CERTIFICATE OF APPROPRIATENESS

Reviewed by the Houston Archaeological and Historical Commission

HPO File#: HP2025_0087

Property: 3506 Audubon Pl, Lot/Tract 13 Block 13, Audubon Place Historic District

Historic Window Standard: New Construction & Replacement

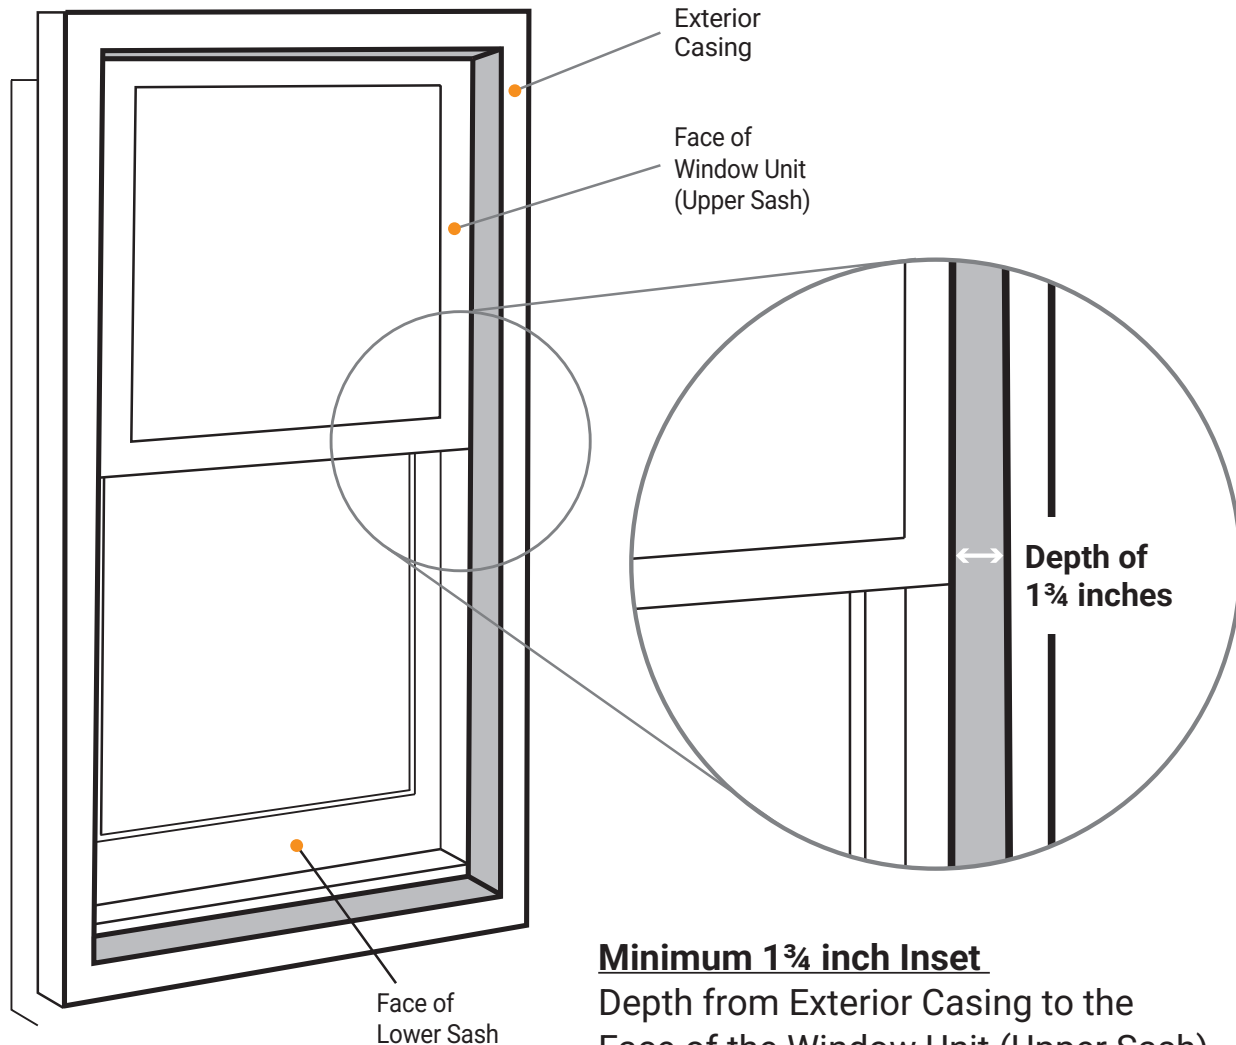
All Windows Must Be Inset a Minimum of 1 3/4 inch: Depth from Exterior Casing to the Face of the Window Unit (Upper Sash) and be equally horizontally divided, **See Attached Historic Requirements Window Diagram.**

- **Replacement with Wood Windows**
- **6-over-1 or 9-over-1** Windows (See Attached Illustration)
- **Window Minimum Inset 1 3/4 inch** (See Attached Diagram)
 - Minimum Inset 1 3/4 inch Depth from Exterior Casing to the Face of the Window Unit, Upper Sash, (equally horizontally divided)
- **1 3/4 inch** minimum inset for **Fixed Window**

Minimum 1 3/4 inch Inset

Depth from Exterior Casing to the Face of the Window Unit (Upper Sash)

Windows must be 1-over-1
(equally horizontally divided)

1 3/4 inch minimum inset for Fixed Window
